National TAB

Project: 10-20-25 QT #0847 GAINESVILLE, GA

Project: 10-20-25 QT #0847 GAINESVILLE, GA
Function: Test, Adjust, & Balance

Issue List

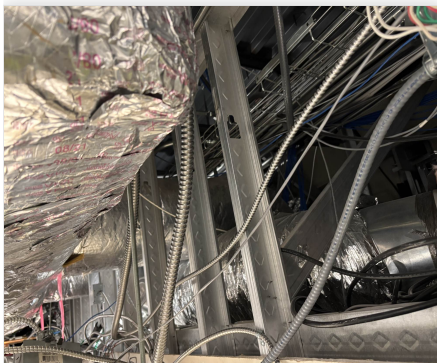
Issue Name : RTU-3: Kitchen Diffusers Incorrect Style
Description : Kitchen diffusers 3-1, 3-2, 3-3, and 3-4 are substitutes until the correct Titus Diffusers can be installed.
Created By : National TAB **Assigned To :** National TAB - Dan Hertenstein
Status : Open
Priority : High **Asset Tag :**
Originated Date : 10/23/2025 - Sagar Patel - National TAB

- **11/25/2025 National TAB - Sagar Patel**
 - Substitute diffusers are still in place of Titus diffusers.

- **11/04/2025 National TAB - Ben Searles**
 - DIFFUSERS REMAIN INCORRECT

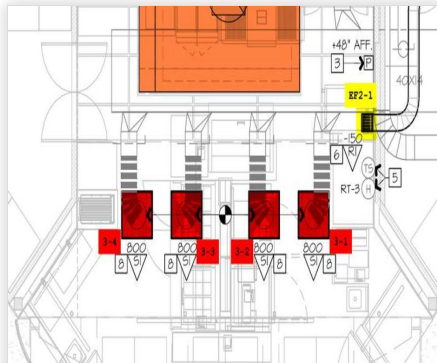
Issue Name : RTU-3: Kitchen Supply Diffuser Ductwork Incorrect
Description : RTU-3 Diffusers 3-1 and 3-4 in the kitchen are not connected to the supply duct. They are still connected to the return duct. This will need to be corrected. RTU 3 is balanced to total design airflow.
Created By : National TAB **Assigned To :** National TAB - Dan Hertenstein
Status : Closed
Priority : Urgent **Asset Tag :**
Originated Date : 10/23/2025 - Sagar Patel - National TAB
